AMENDED IN RED

**PLANS AND DOCUMENTS
referred to in the PDA
DEVELOPMENT APPROVAL**

Approval no: DEV2017/831

BUSHFIRE RISK HAZARD ANALYSIS Teviot Downs, North of Pub Lane.

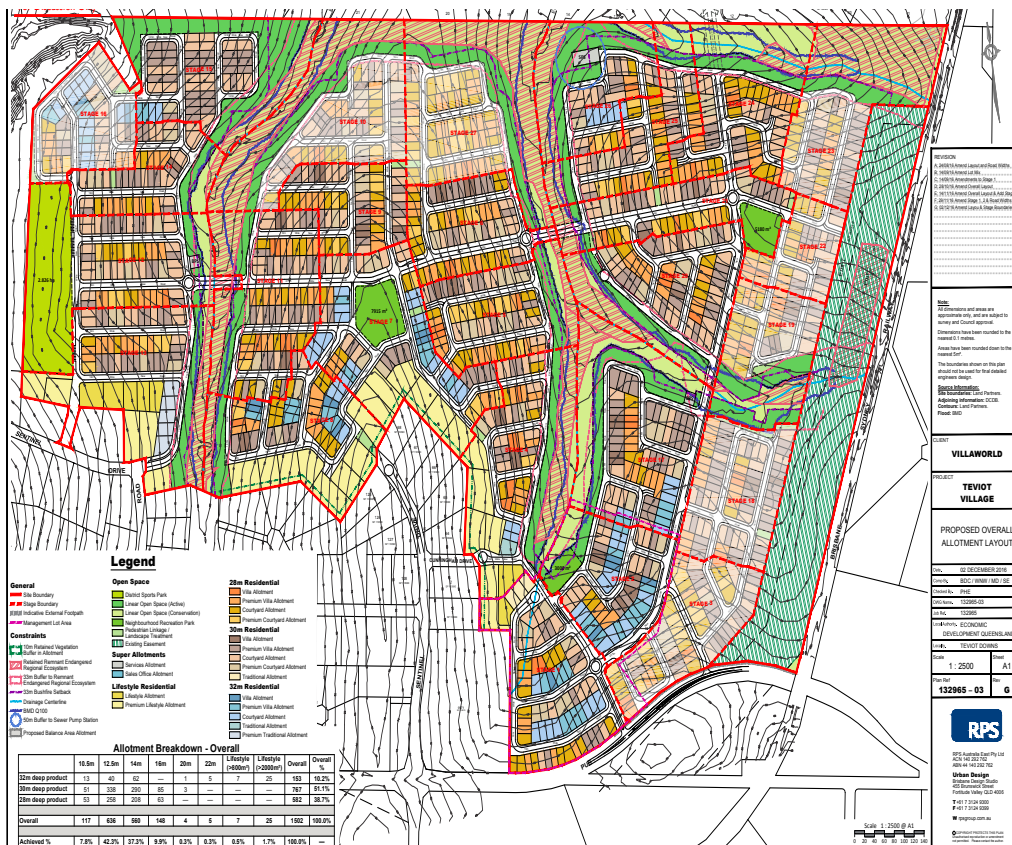
~~Where the above recommendations are implemented in full, no elevated construction measures under AS3959 are necessary for dwellings established on the residential lots illustrated on the development layout (Refer Figure 2).~~

Where the above recommendations are implented in full, no elevated construction measures under AS3959 may be required, however the bushfire risk of a property will need to be confirmed at the building stage to determine the level of construction required to address any potential bushfire impacts.
